IEEE P802.15
Wireless Personal Area Networks

Project	IEEE P802.15 Working Group for Wireless Personal Area Networks (WPANs)		
Title	**LB97 resolutions - Kivinen**		
Date Submitted	11 July, 2014		
Source	Tero Kivinen INSIDE Secure Eerikinkatu 28 FI-00180 Helsinki Finland	Voice: Fax: E-mail:	+358 20 500 7800 +358 20 500 7801 kivinen@iki.fi
Re:	LB97 resolutions		
Abstract	LB 97 resolutions to CIDs 1028, 1150, 1026, 1145, 1146, 1148, 1147, 1153, 1101, 1151, 1105, 1104, 1154, R41 and R42		
Purpose	LB97 resolutions		
Notice	This document has been prepared to assist the IEEE P802.15. It is offered as a basis for discussion and is not binding on the contributing individual(s) or organization(s). The material in this document is subject to change in form and content after further study. The contributor(s) reserve(s) the right to add, amend or withdraw material contained herein.		
Release	The contributor acknowledges and accepts that this contribution becomes the property of IEEE and may be made publicly available by P802.15.

New version of the Outbound state machine:

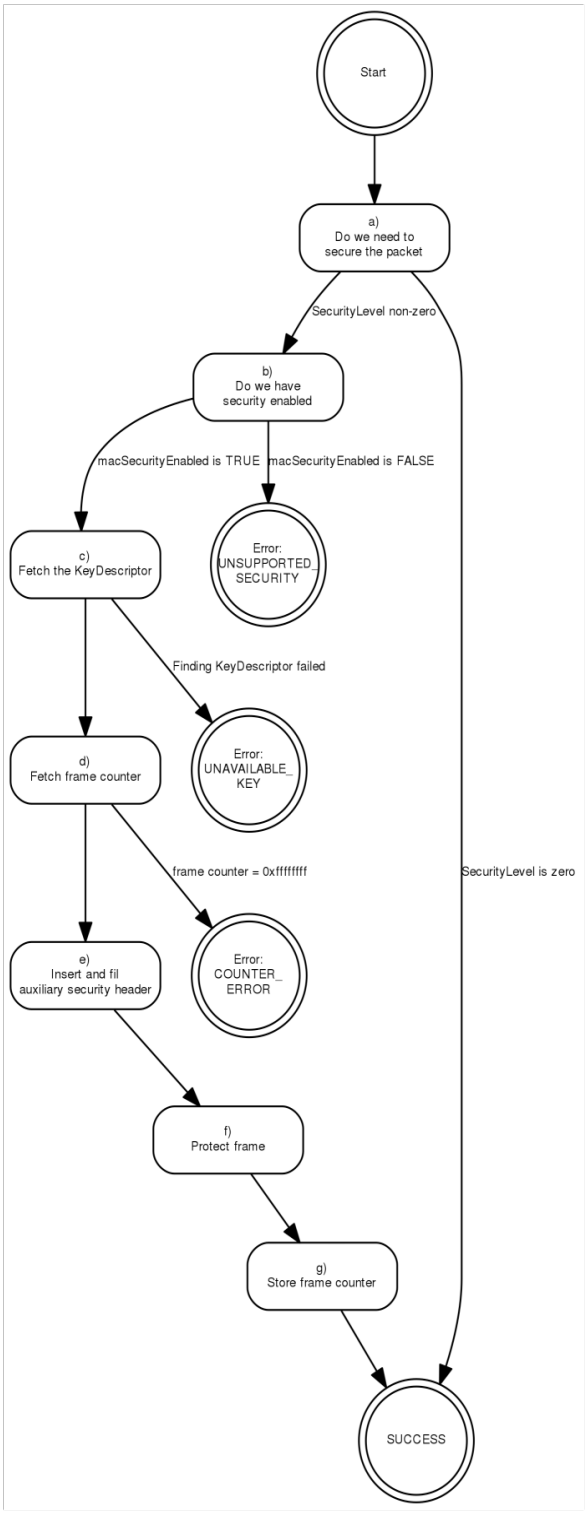
Robert Moskowitz	Verizon	313	9.2	16	Still need state machines for security flow	Provide state machine figures

Tero Kivinen	INSIDE Secure	313	9.2.1	37	Swap steps c) and b). There is no point of checking length of the data expansion length if we are not protecting the frame. See CID 565.	Swap steps c) and b).

Outbound state machine done, see CID 1150 for it.
Inbound state machine done, see CIDs 1153, 1101, R41, R42 for it.

a) Do we need to secure the packet?

If the SecurityLevel parameter is zero, the procedure shall set the secured frame to be the frame to be secured and return with a status of SUCCESS.

b) Do we have security enabled?

If the *macSecurityEnabled* attribute is set to FALSE the procedure shall return with a status of UNSUPPORTED_SECURITY.

CID 1153, 1101, R41, R42

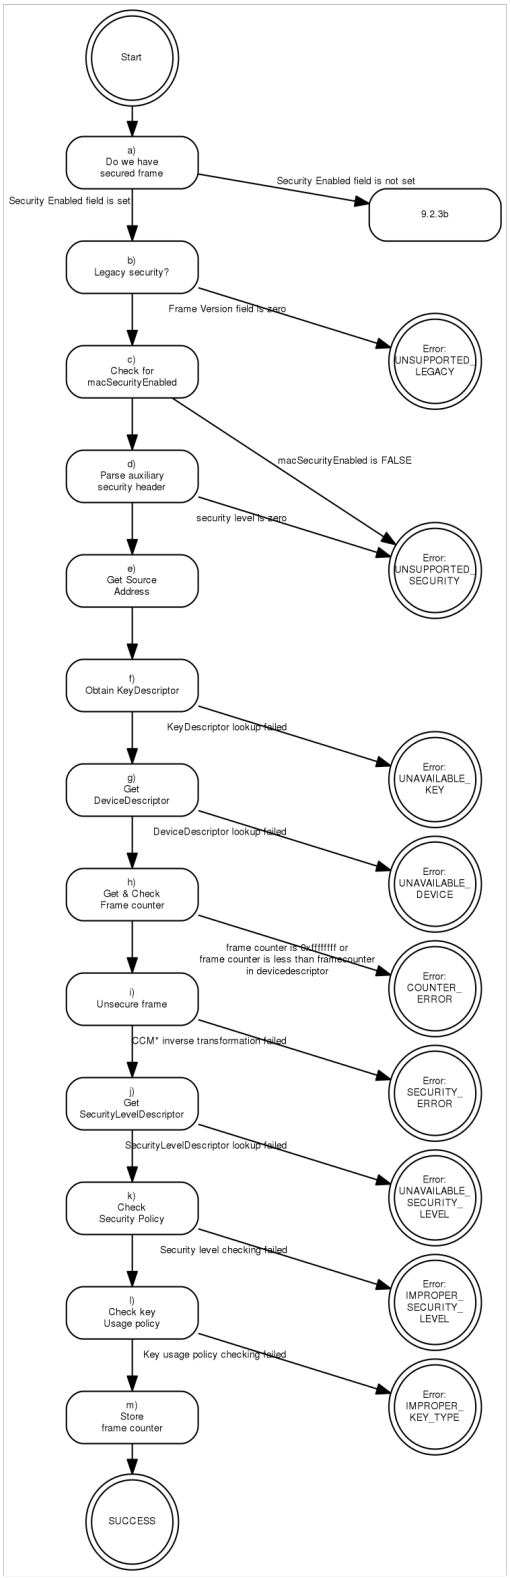
Tero Kivinen	INSIDE Secure	315	9.2.3	49	Both steps c) and steps e) will set “key identifier mode” / “KeyIdMode”, “key source”/”KeyIndex” and “key index”/”KeyIndex”. I think we need to do this only once.	Modify the step c) so it will copy the values out from the auxiliary security header, and remove the copying from step e), so all auxiliary security header processing is in one step. We need to check which names of those local variables needs to be used in the rest of the processing steps, and perhaps also change them to use separate typographical look.
Tero Kivinen	INSIDE Secure	316	9.2.3	50	CID 470 was not done: In step l) the step will check the frame counter value of 0xffffffff. With TSCH mode the frame counter is not used, instead of 5-octet absolute slot number ASN is used, this test is not needed. Actually the current draft accidently did that change for step i) not for step l), so move the text from step “i) … procedure shall determine whether the frame to be unsecured ...” to step “l) The procedure shall set frame counter …”.	Add ”If not using TSCH mode” in front of step l.

Tero Kivinen	INSIDE Secure	316	9.2.3	35	Steps i), j) and k) should be folded in to the step h. It is stupid to call subprocedure to fetch the SecurityLevelDescriptor and then check it here, as we could call SecurityLevelDescriptor validation procedure, that will get that SecurityLevelDescriptor and verify the packet is according to it, and then either return error (either UNAVAILABLE_SECURITY_LEVEL or IMPROVED_SECURITY_LEVEL) or SUCCESS, or pass forward.	As described in the Comment section.
Tero Kivinen	INSIDE Secure	316	9.2.3	49	Steps l and m should be combined.	Replace with “If not using TSCH mode, the procedure shall set frame counter to the Frame Counter field of the frame to be unsecured. If frame counter has the value 0xffffffff, or if the frame counter is less than the FrameCounter element of the DeviceDescriptor, the procedure shall return with a status of COUNTER_ERROR.”

The input to this procedure is the *frame to be unsecured*. The outputs from this procedure are the *status* of the procedure and, if this *status* is SUCCESS, the *unsecured frame*, the *security level*, the *key identifier mode*, the *key source*, and the *key index*.

The incoming frame security procedure involves the following steps:
